SERVICE BULLETIN

ALL LEGACY MODELS, INCLUDING TURBO

EXHAUST PIPE "EPR" WHISTLING NOISE

Figure 1

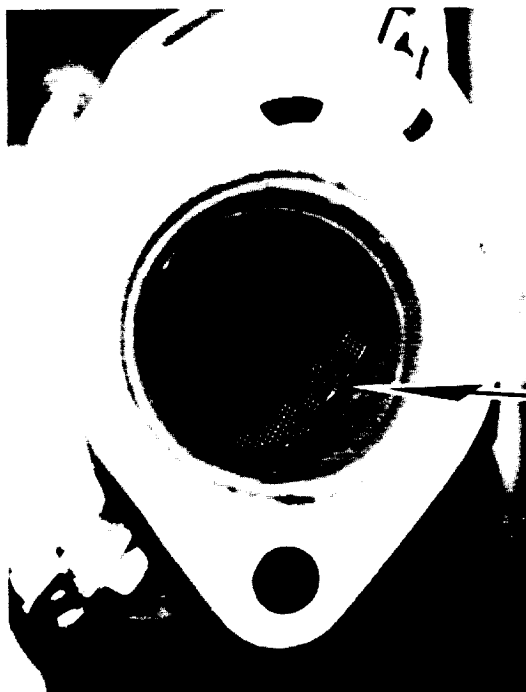
Visually examine the rear catalytic converter inlet shield ring for a bend in the ring in the shape of a "VEE". See Figure 1, below.

Using compressed air and an air blow gun, with a tip 6 to 8 inches long, blow air around the shield ring. If the shield ring begins to whistle the "EPR" or rear pipe needs to be replaced. EPR pipes, produced on and after October 1, 1992, will have a modified shield ring to prevent the whistling sound. See Figure 2 for production code identification.

If you are replacing the EPR pipe with a pipe before the production change you will need to perform the shield ring test as described in the opening paragraph.
